RE: Anthony Forest Products Compan Inspections (Union Co) AFIN: 70-00473 NPDES Permit No.: AR0047384 ARG550398 ARG550540 ARR000977

Inspection Report: Anthony Forest Products Compan, AFIN: 70-00473, Permit #: AR0047384

RE: Anthony Forest Products Company, LLC Compliance Inspection Response AFIN: 70-00473
 NPDES Permit No. AR0047384, Permit Tracking No. ARR000977, Permit Tracking No. ARG550398, and Permit Tracking No. ARG550540

Attachment 1 Outfall 001 Photo

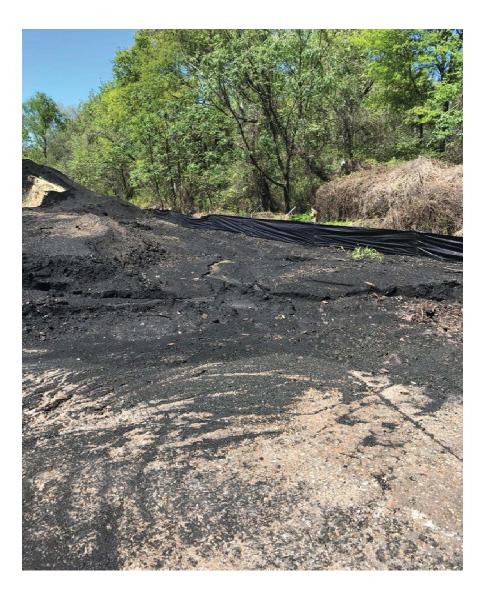
During the inspection, I observed materials in the weir box and roots growing up and through the V-notch weir used to measure flow at Outfall 001 (see Photo 1). The flow device needs to be maintained to be free of turbulence and materials that would affect the flow measurement. An image of the weir properly maintained will be required as a response to this violation.

The flow device at Outfall 001 is not maintained to provide adequate volume of monitored discharges. Materials were observed in the weir box and roots growing up and through the V-notch weir.

Vines, roots, and debris have been removed from the weir and weir box. Pictures showing the above described corrective actions can be found in Attachment 1.

Attachment 2 Outfall 011 Photos

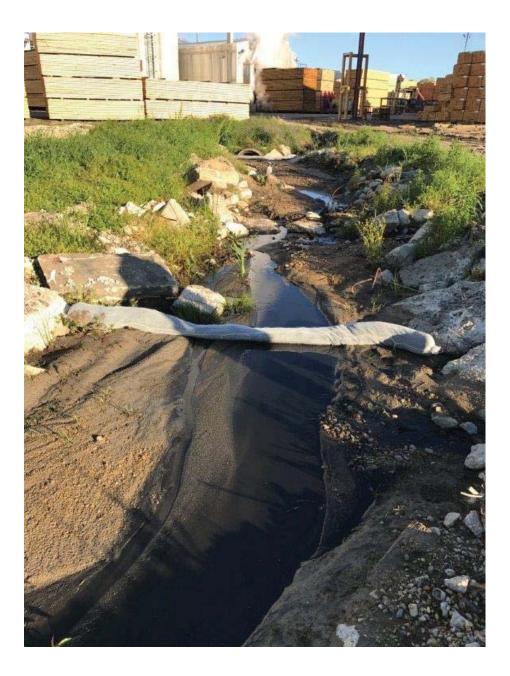
The facility has kiln ash pile with no control measures that is contributing to pollution of UT of Woodard Creek.

Silt fence has been added to the downstream side of the kiln ash pile as a temporary control measure. Pictures showing the above described corrective action can be found in Attachment 2.
